AXOD/AXODE (AX4S) UPDATE HANDBOOK

INTRODUCTION

*Updated
October, 2002*

Figure 101

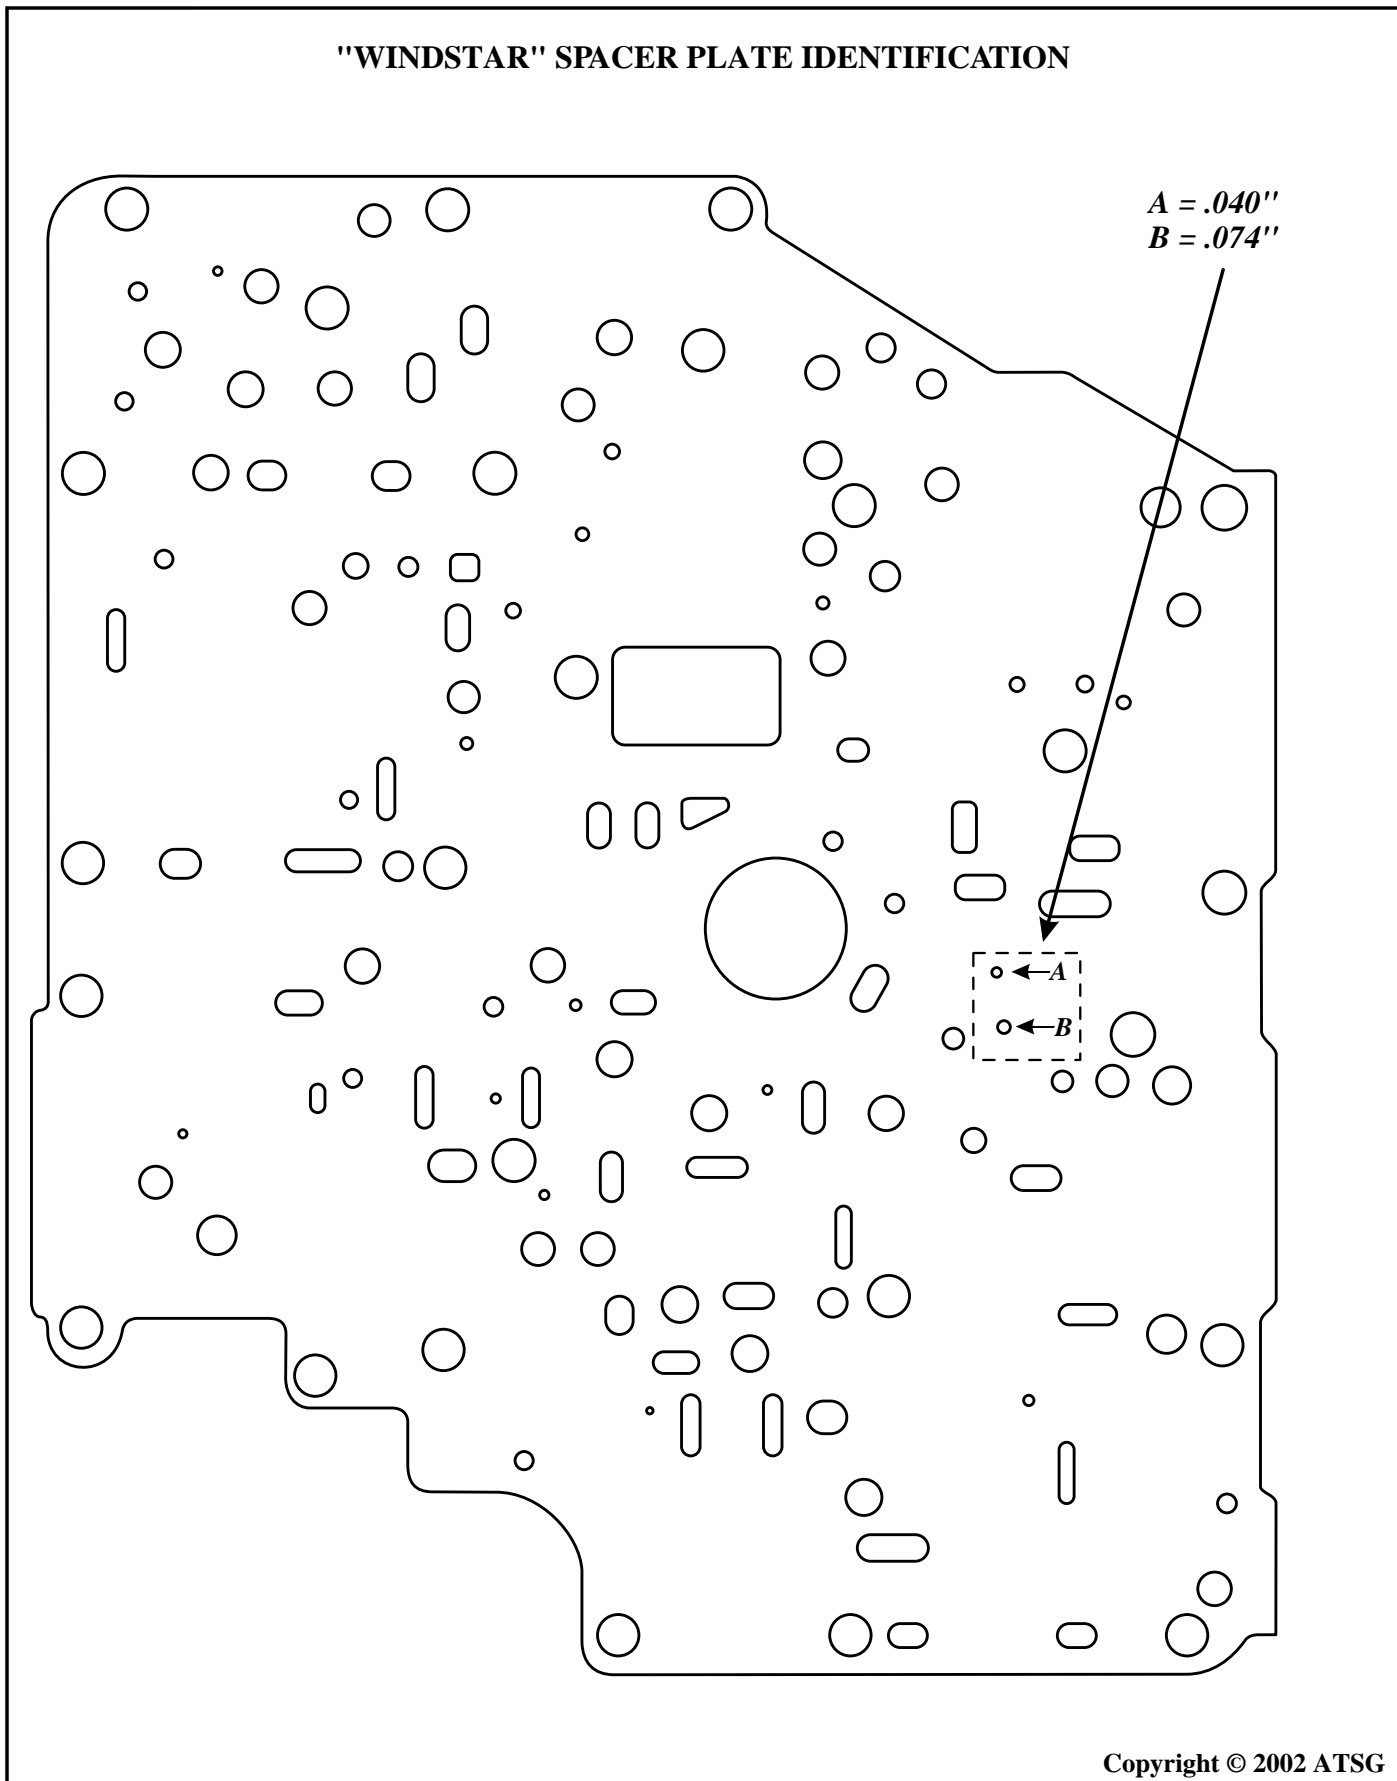
COMPLAINT: Some 1995-Up Ford Windstar Vans may exhibit a harsh 1-2 upshift, either before and/or after overhaul of the transaxle. Some 1995-Up Ford Taurus, Mercury Sable or Lincoln Continental may exhibit a soft or flare on the 1-2 upshift either before or after overhaul.

CAUSE: The cause may be, a valve body spacer plate designed for the Taurus, Sable, Continental passenger car family, has been installed on a Windstar Van, creating a harsh 1-2 upshift. If the Windstar Van valve body spacer plate, is installed on the Taurus, Sable, Continental family of vehicles, the result will be a soft or flared 1-2 upshift. ***Obviously these two spacer plates are different.*** Refer to Figures 101 and 102, using the two holes over the 1-2 capacity modulator valve area, for identification.

CORRECTION: Install the proper valve body spacer plate for the Ford family that you happen to be servicing at this time. Refer to the illustration in Figure 101 to identify the valve body spacer plate for the Windstar Van. Refer to the illustration in Figure 102 to identify the valve body spacer plate for the Taurus, Sable and Continental family.

Figure 103

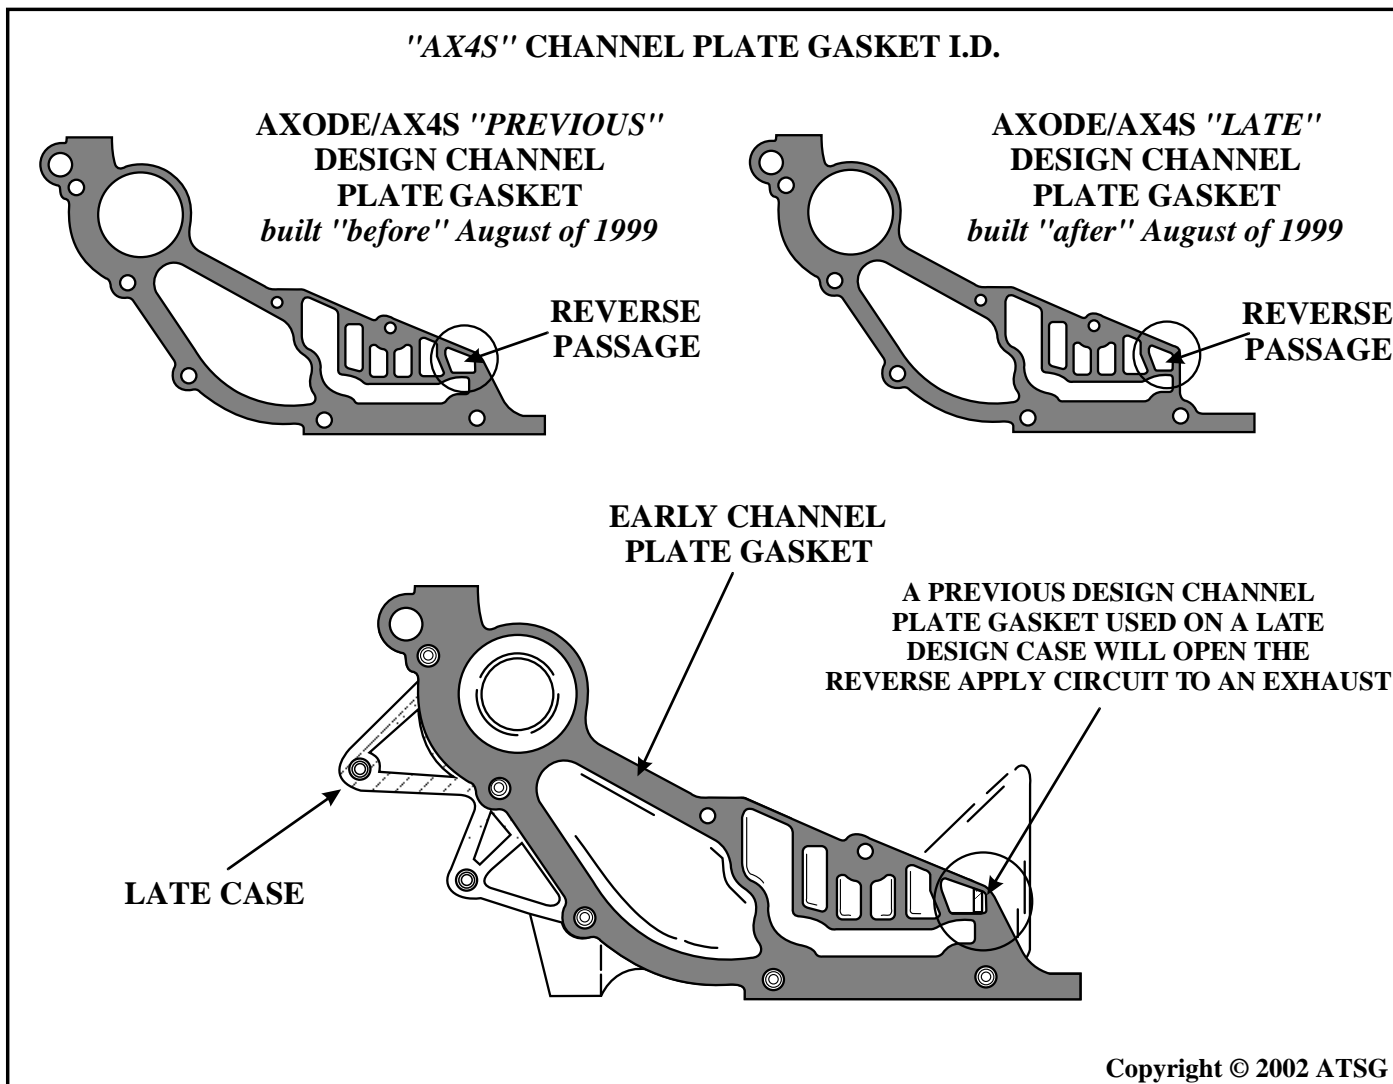
CAUSE: The cause may be, that the *Previous Design* Channel Plate Gasket, was used on a *Late Design* case as shown in Figure 103. When this happens, Reverse apply pressure will be exhausted back into the case because of the gasket hanging over the case casting.

CORRECTION: AX4S-Refer to Figure 103 to identify the correct Channel Plate Gasket for the application of vehicle you are working on.
AX4N-Refer to Figure 104 to identify the correct Channel Plate Gasket for the application of vehicle you are working on.
